Eastern Creek Business Hub

Design Guidelines

For: Western Sydney Parklands Trust

Date: ~~12th February, 2014~~ **10 March, 2017**

Figure 3: Indicative Landscape Master Plan (~~Urbis~~) (Group GSA)

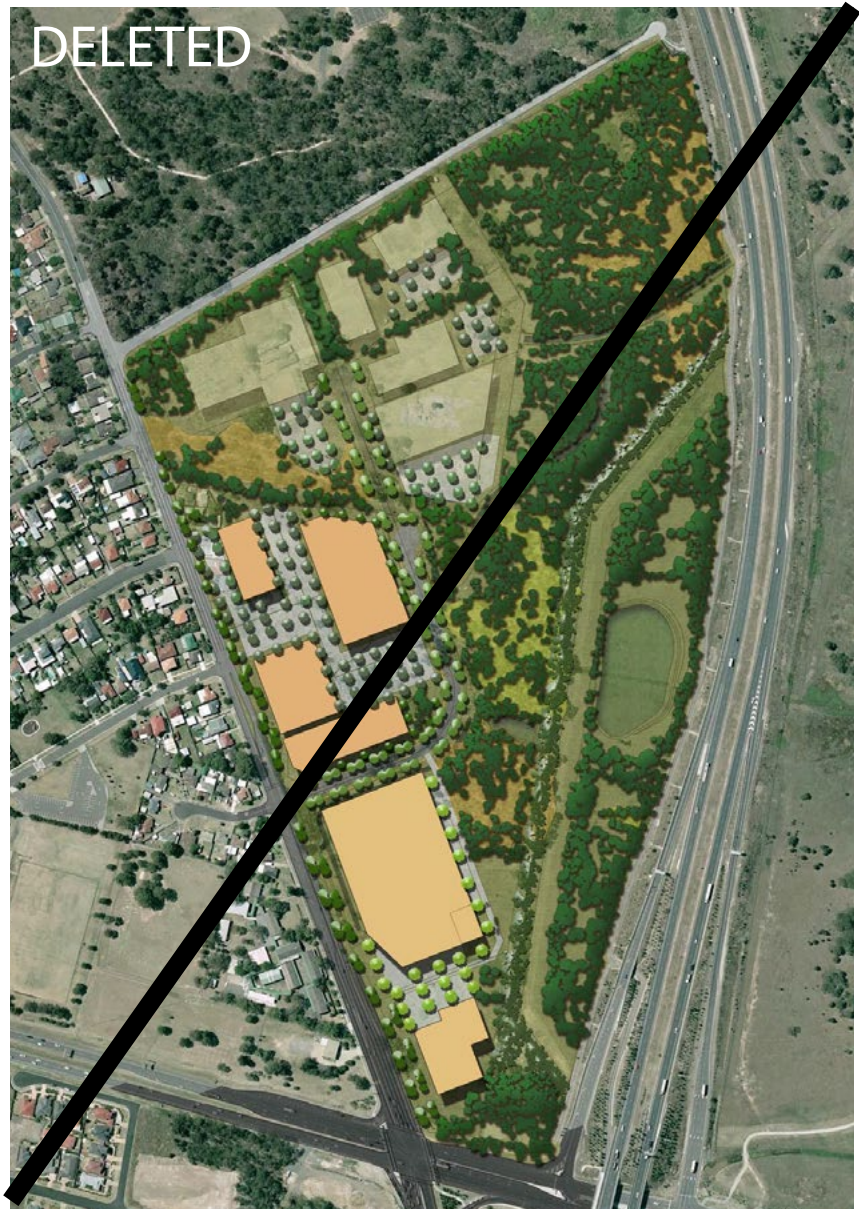
INSERTED

Figure 3: Indicative Landscape Master Plan (Group GSA)

Figure 11: Vehicle access

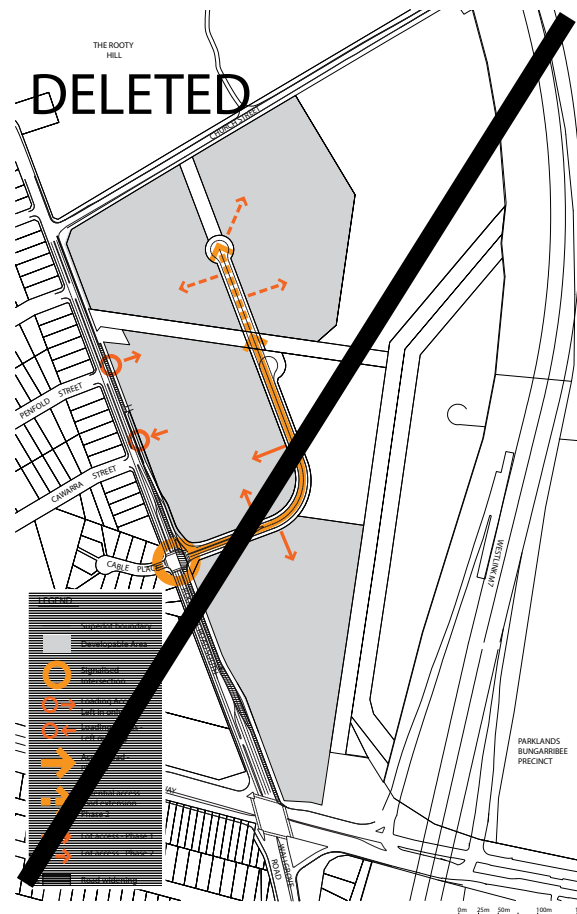
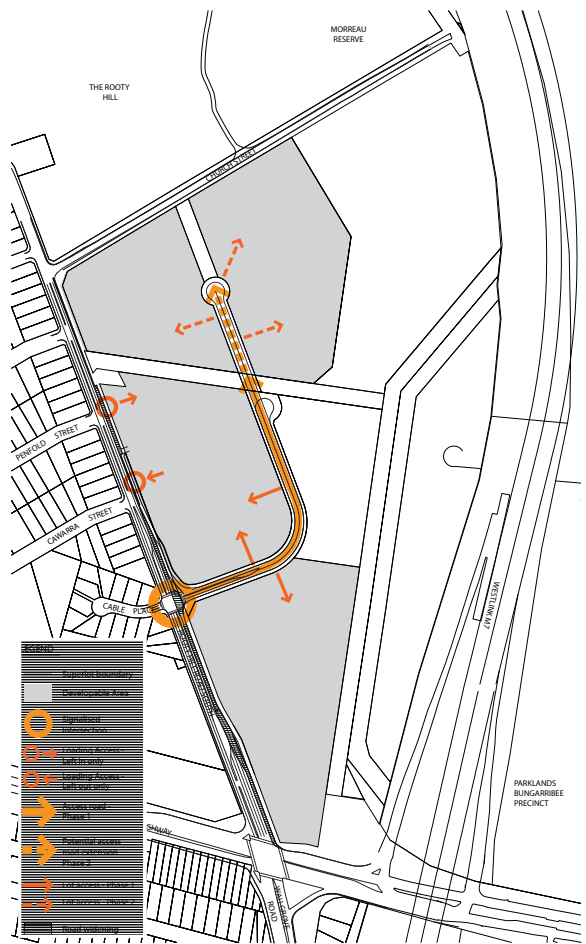
INSERTED

Figure 11: Vehicle access

Figure 27: Illustrative Village Centre Landscape Master Plan (Urbis) Figure 26: Illustrative Village Centre Landscape Master Plan (Group GSA).

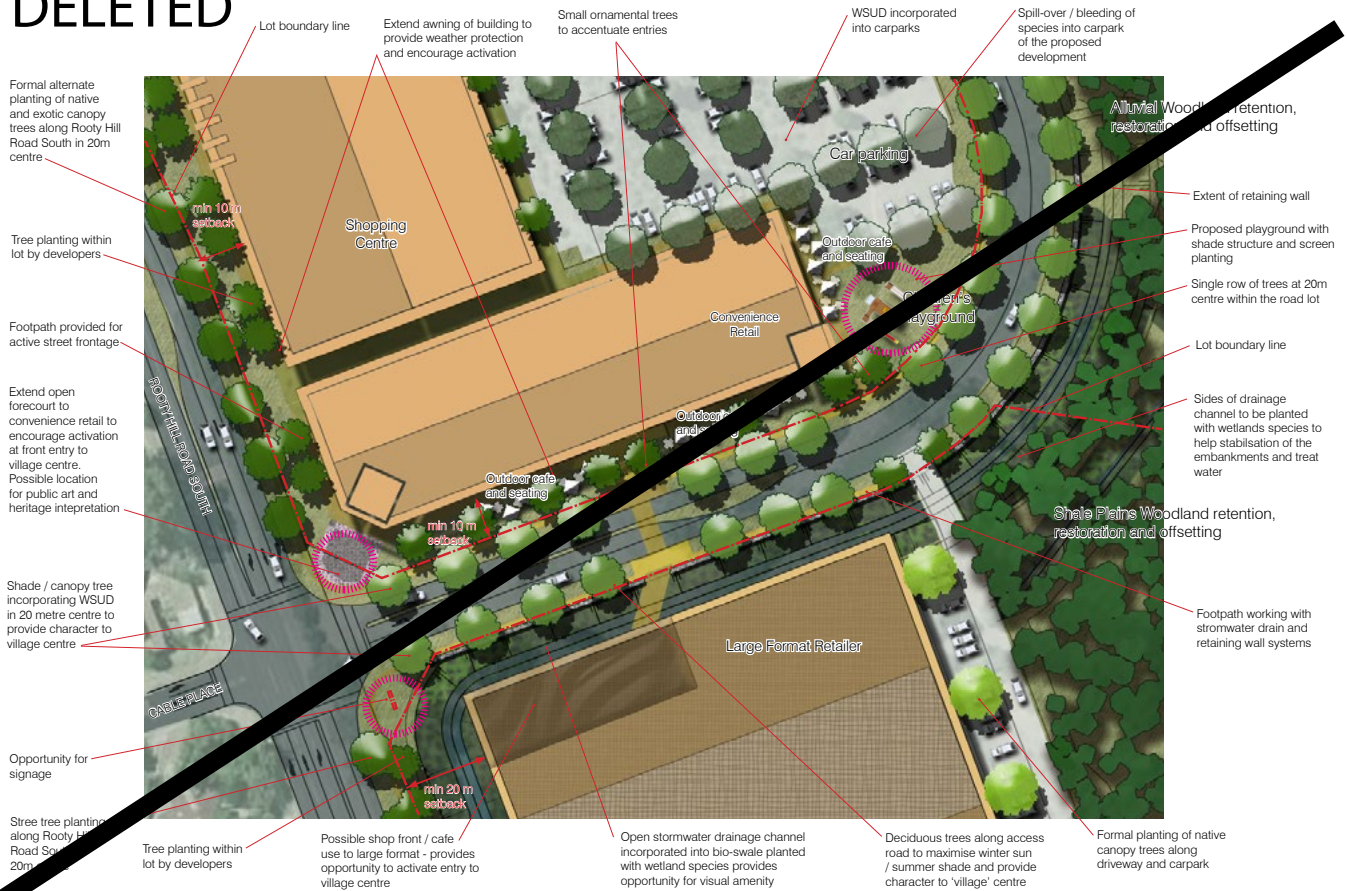
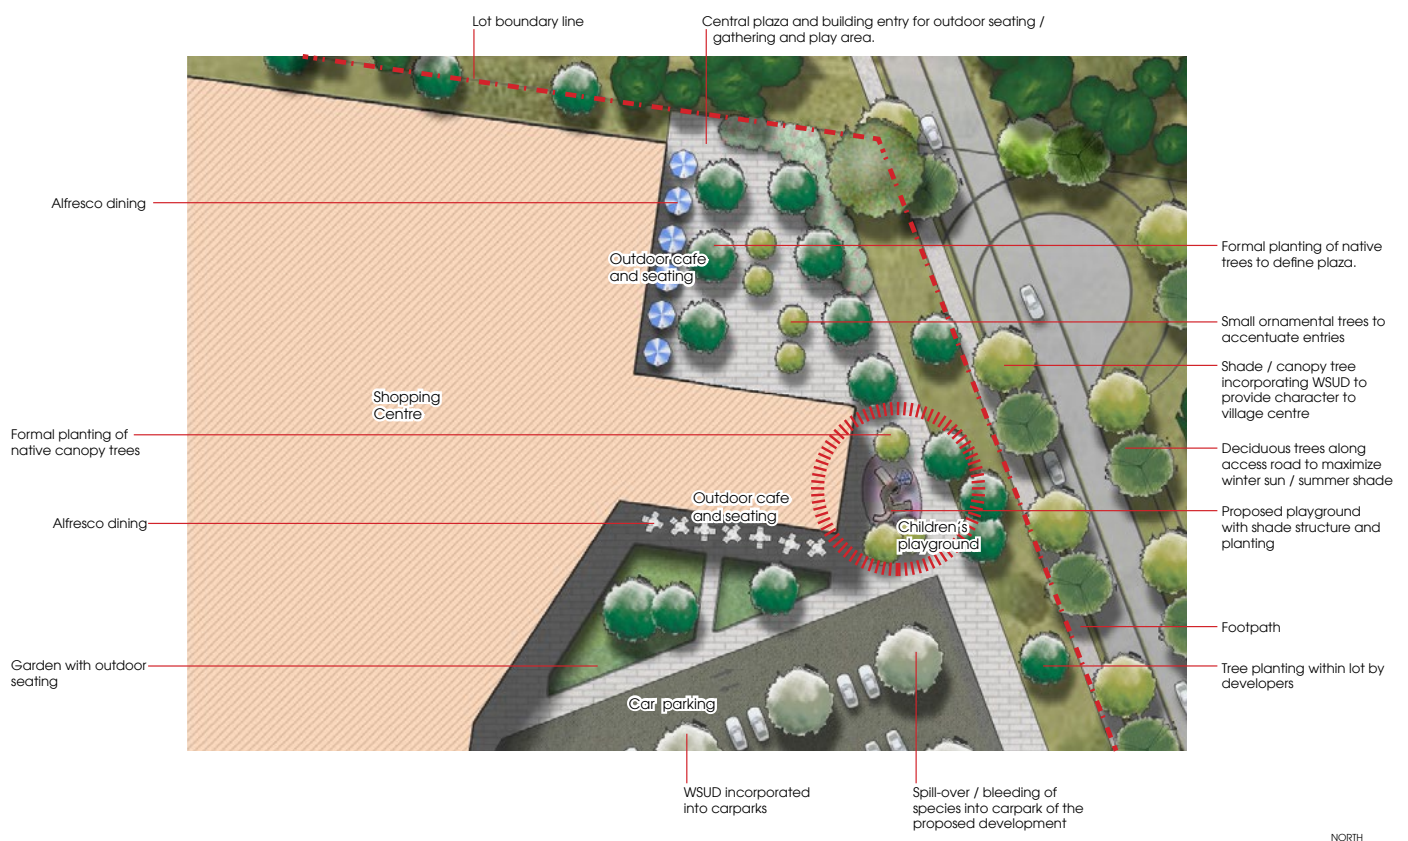
INSERTED

Figure 26: Illustrative Village Centre Landscape Master Plan (Group GSA)

Figure 28: Illustrative Landscape Master Plan (Urbis) Figure 27: Landscape Master Plan (Group GSA).

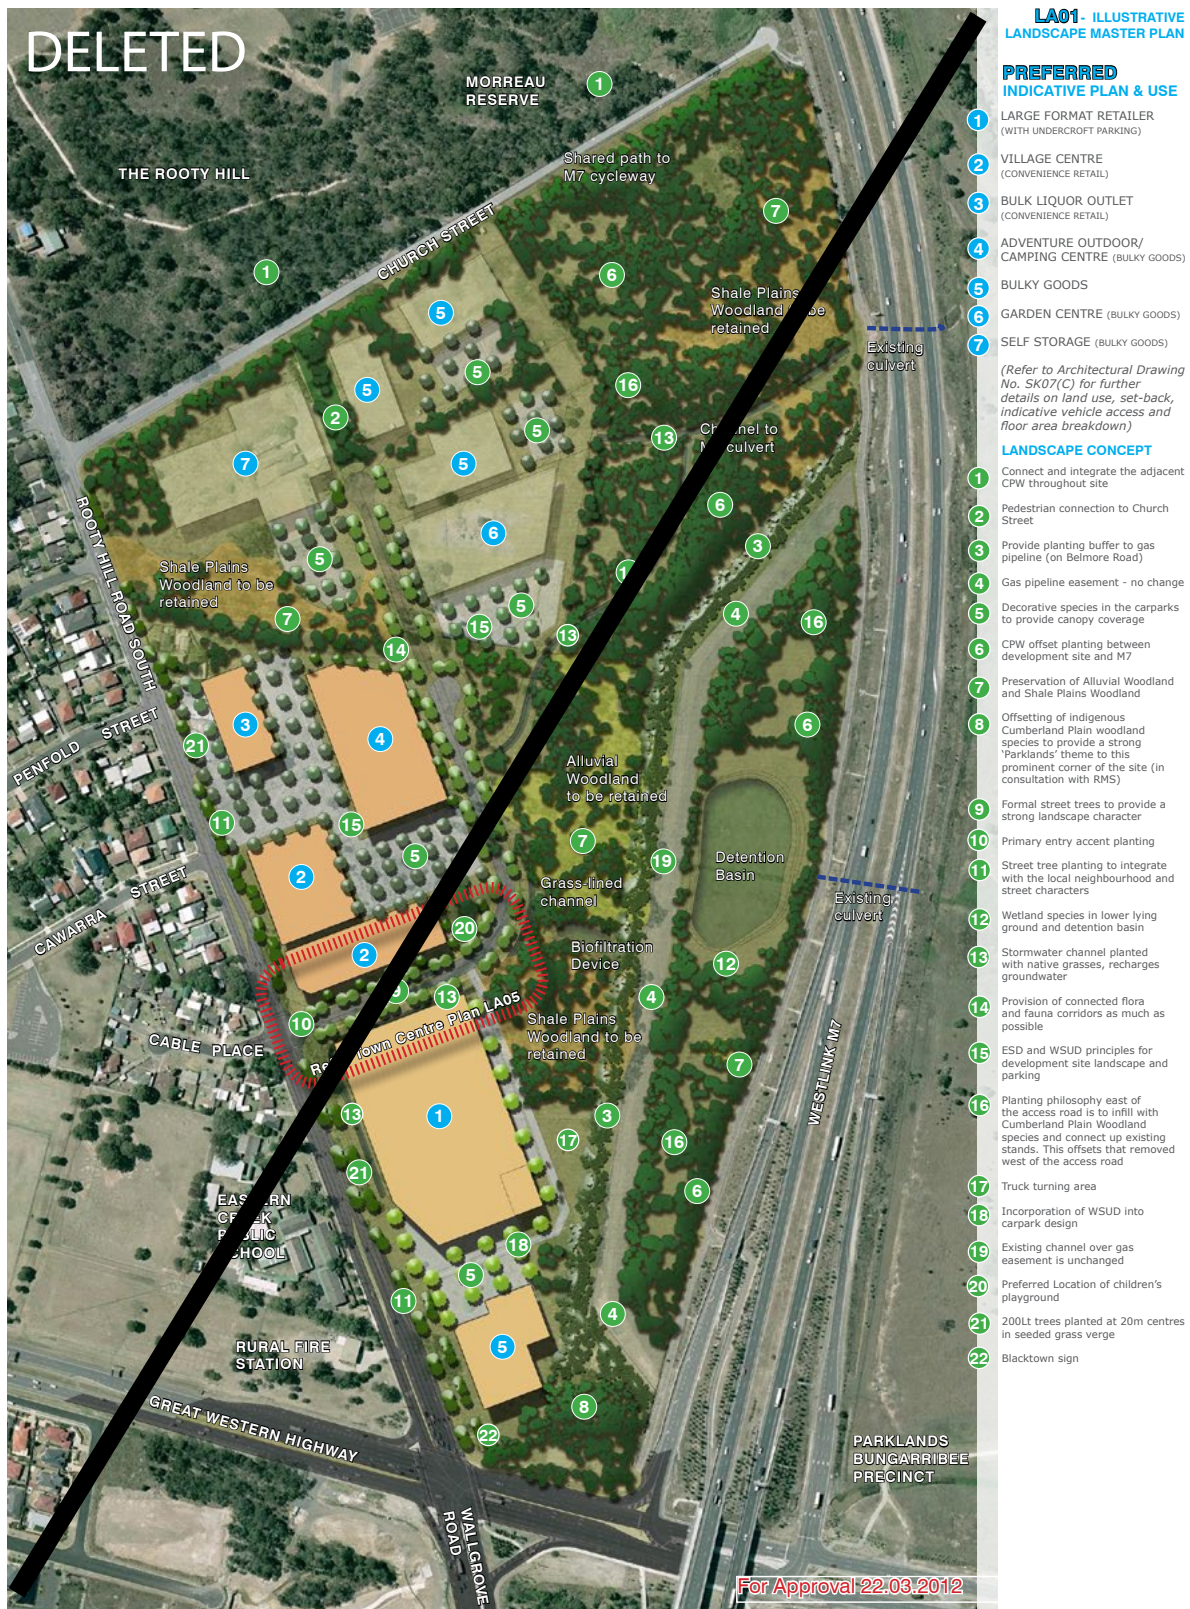
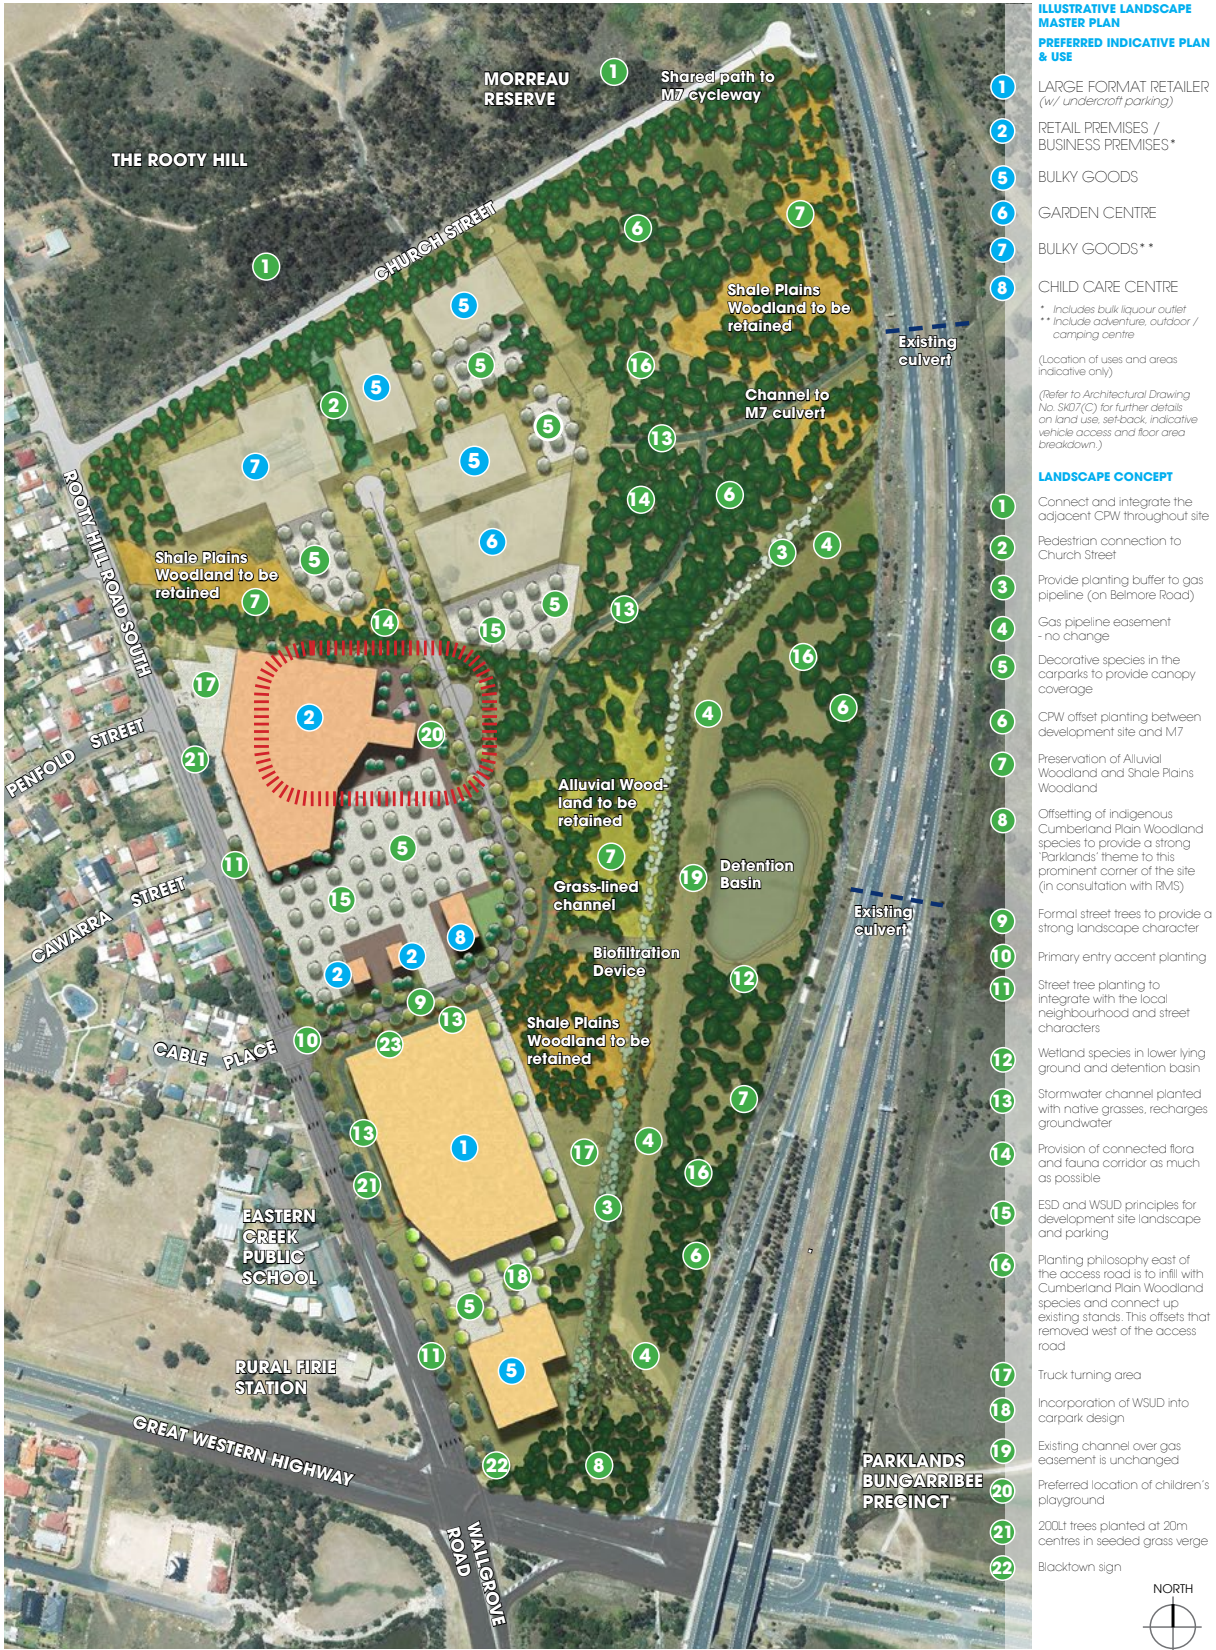
INSERTED

Figure 27: Illustrative Landscape Master Plan (Group GSA)

Figure 31: Large Lot Subdivision Figure 30: Indicative Lot Subdivision Option 1

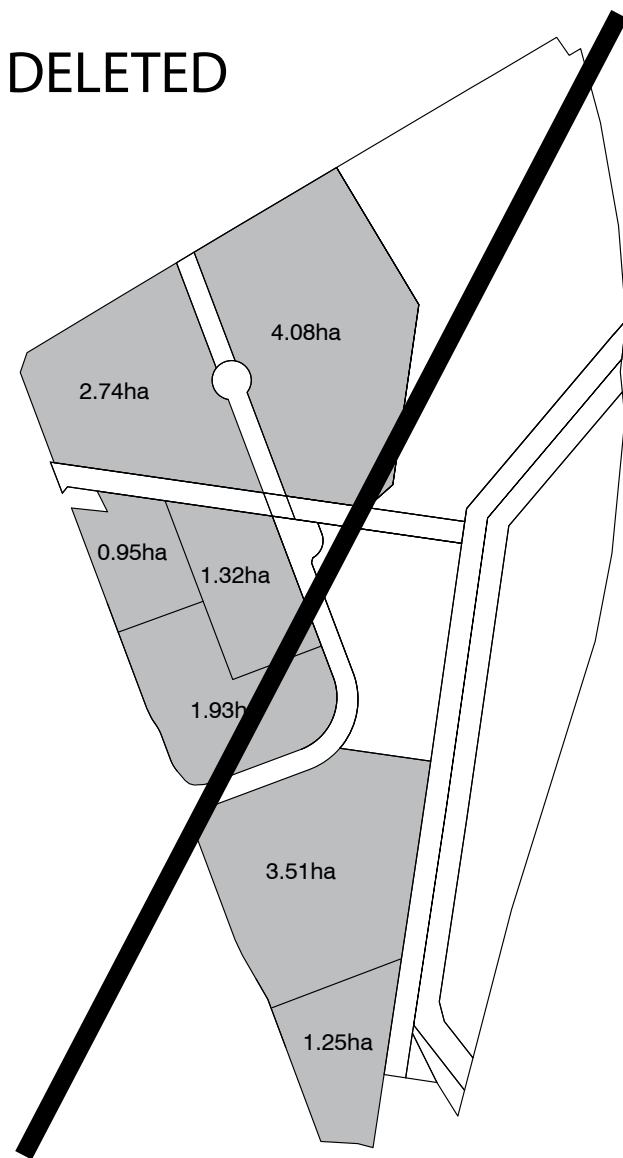
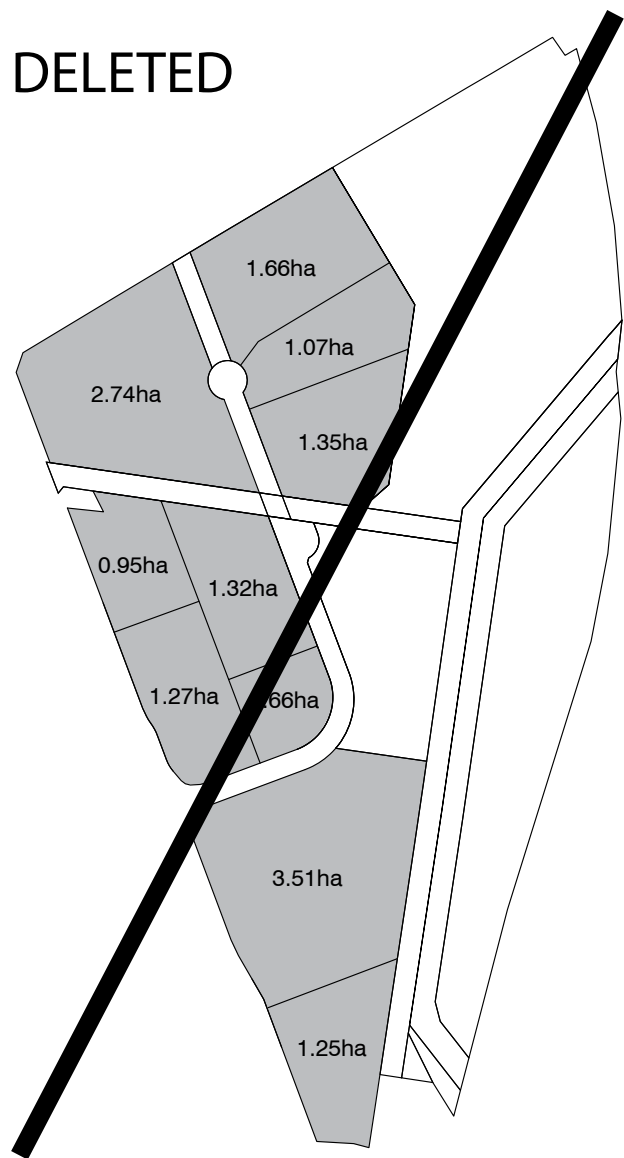
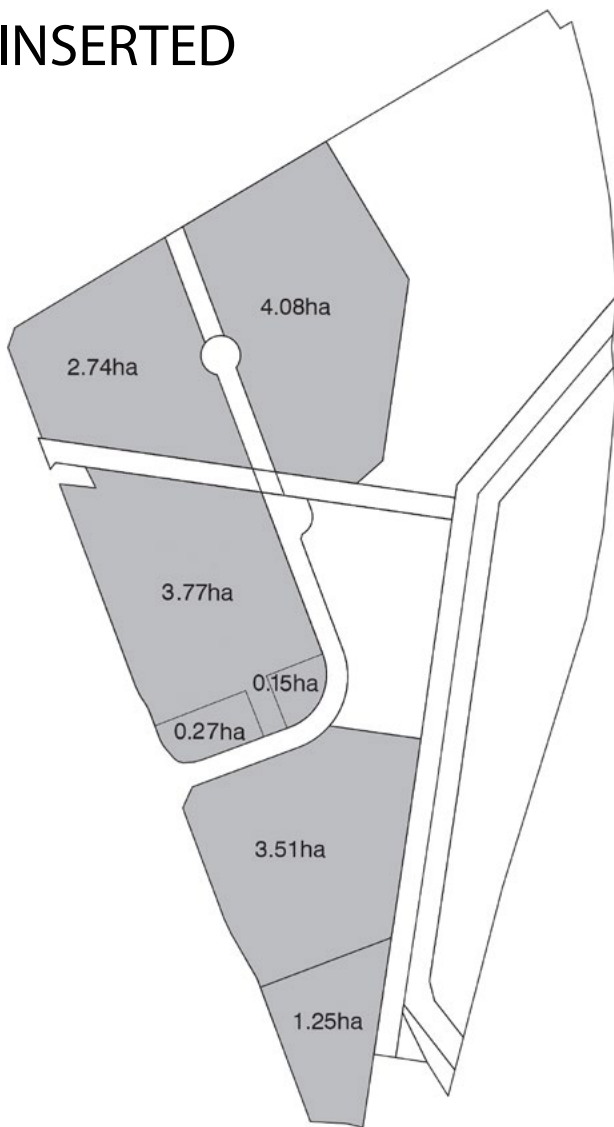
Figure 32: Medium Lot Subdivision Figure 31: Indicative Lot Subdivision Option 2

INSERTED

Figure 30: Indicative Lot Subdivision Option 1

Figure 31: Indicative Lot Subdivision Option 2
